Attachment B-2

**JUNEAU-RIVERSIDE AND STEPHEN
RICHARDS CONGESTION MITIGATION**

SIGNAL PLAN

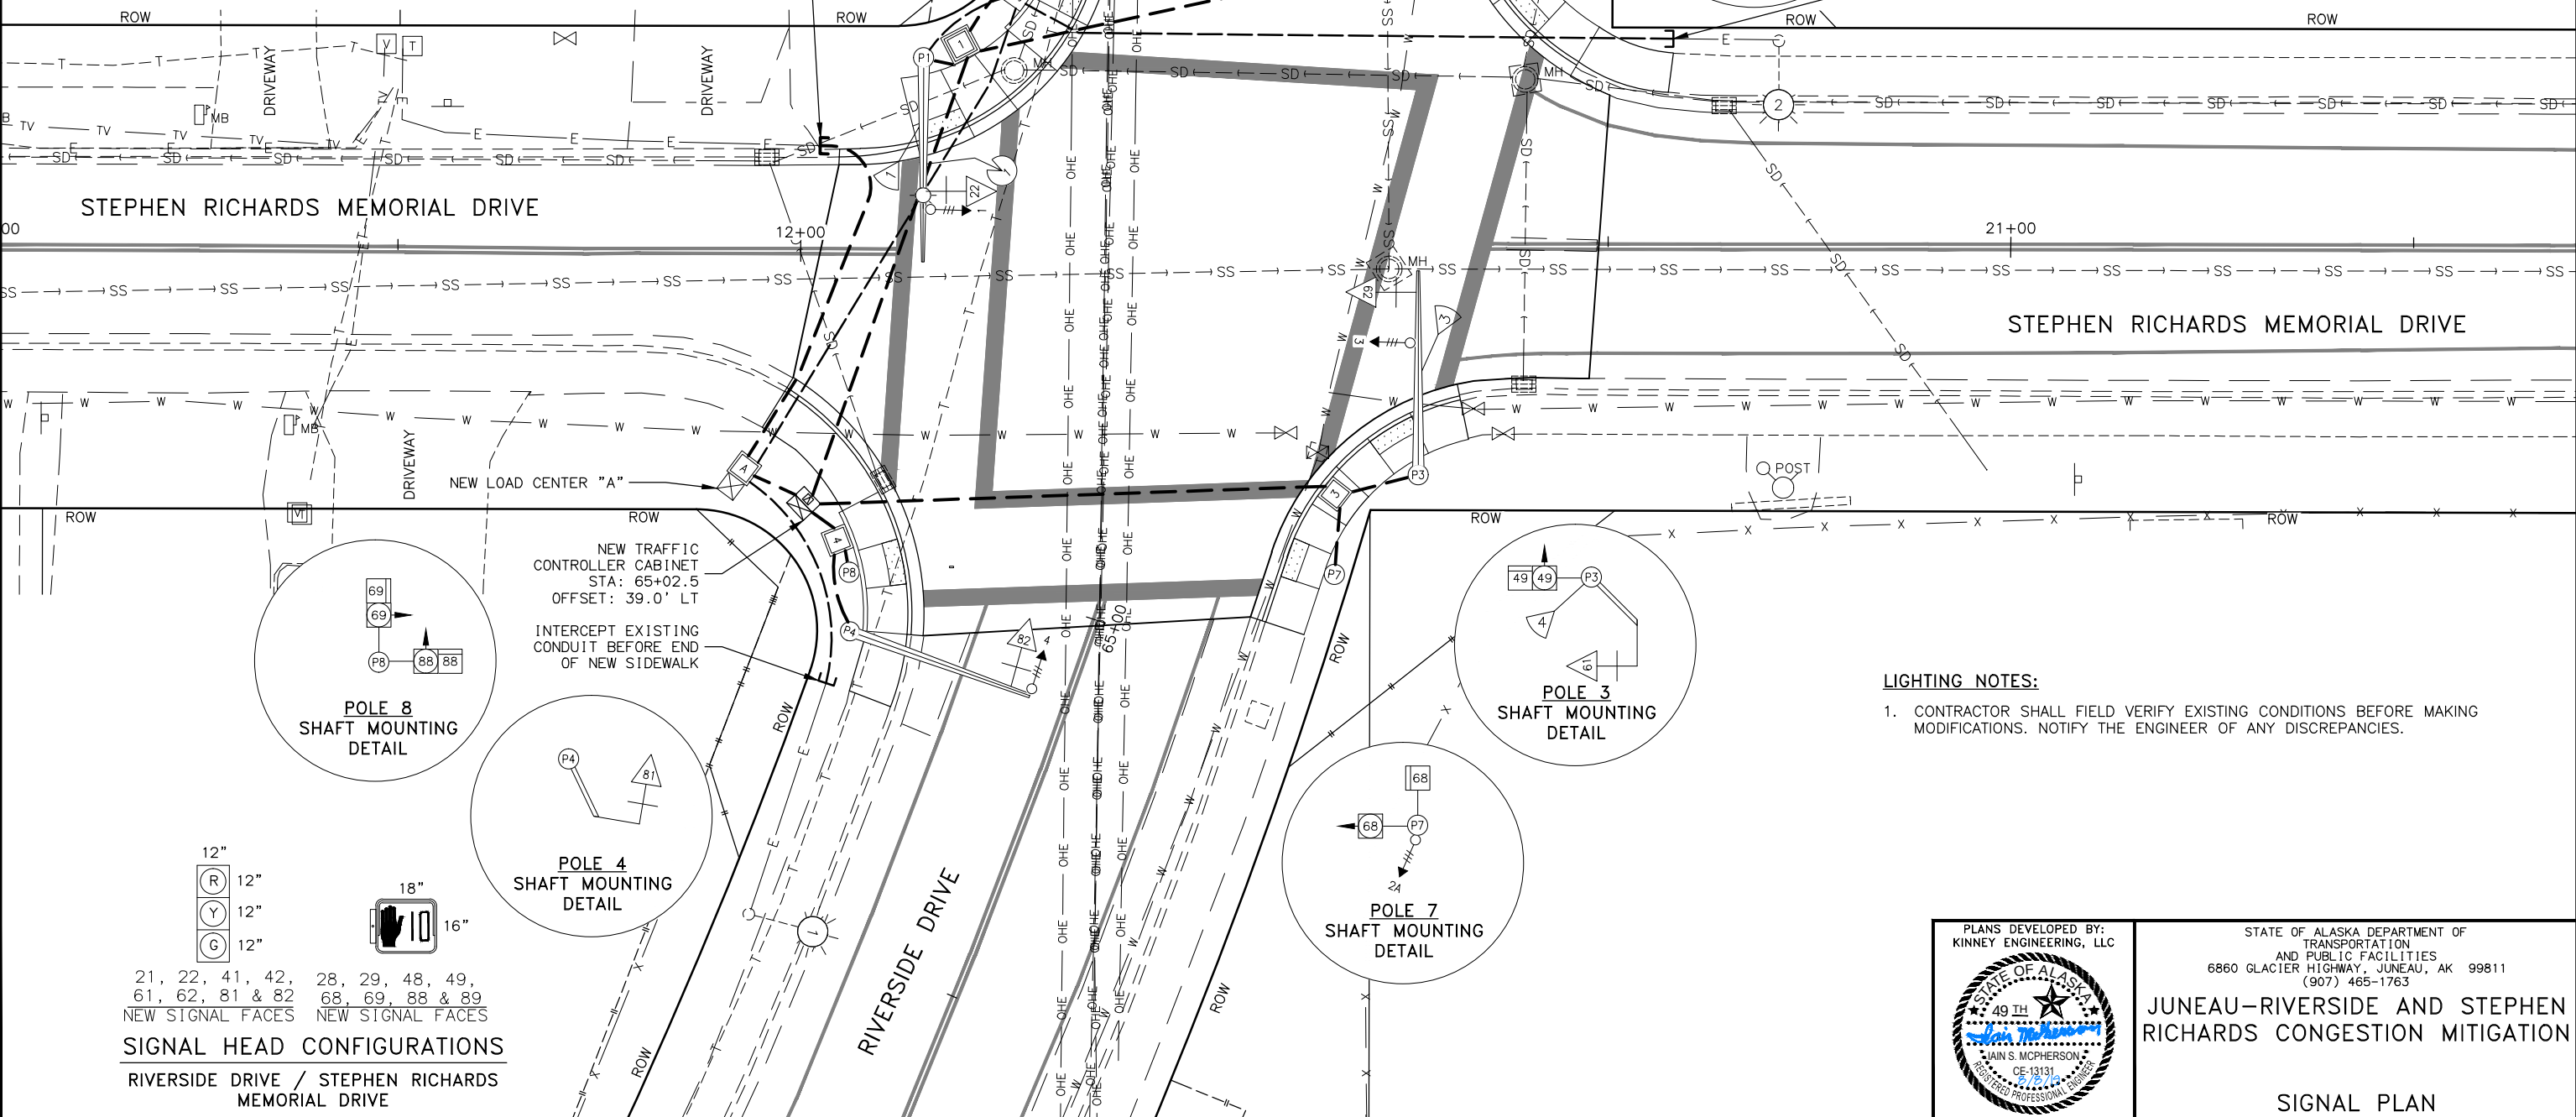
INTERCEPT EXISTING CONDUIT RUNNING TO EXISTING METER BEFORE DRIVEWAY

INTERCEPT EXISTING CONDUIT BEFORE THE END OF NEW SIDEWALK.
